BRISTOL AEROSPACE
LIMITED

ENGINEERING MEMORANDUM

FLOORBOARD MOD. FOR
SPAR ATTACHMENT ACCESS

15829

FIG. 1
LH PANEL SHOWN
RH OPP.

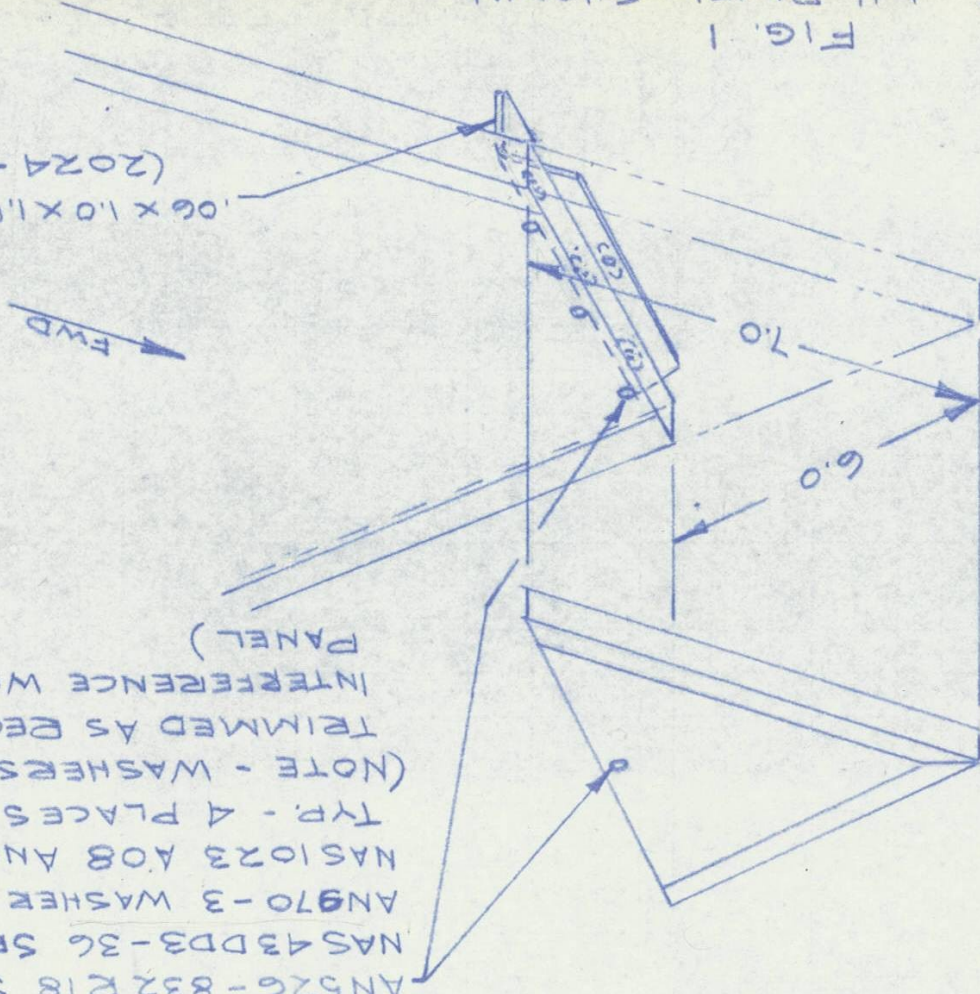
IN ORDER TO AVOID THE COMPLETE REMOVAL OF THE FLOORBOARDS AND APPLICABLE EQUIPT. AND FURNISHINGS FROM THE CABIN WHEN INSPECTIONS AND/OR SERVICING OF THE FUSELAGE / MAIN SPAR ATTACHMENT ARE REQUIRED, MAKE A SMALL REMOVABLE PANEL FROM THE FWD OUTBD CORNER OF THE EXISTING FLOORBOARD AS SHOWN ON FIG. 1. THE ANGLE SUPT. MAY BE CUT AS REQD. TO CLEAR EXIST. STRUCTURE.

AN526-832 R18 SCREW
NAS43DD3-36 SPACER
AN970-3 WASHER
NAS1023 A08 ANCHOR NUT
TYP. - 4 PLACES
(NOTE - WASHERS TO BE
TRIMMED AS REQD TO AVOID
INTERFERENCE WITH ADJACENT
PANEL)

06 X 1.0 X 1.5 ANGLE
(2024-13)
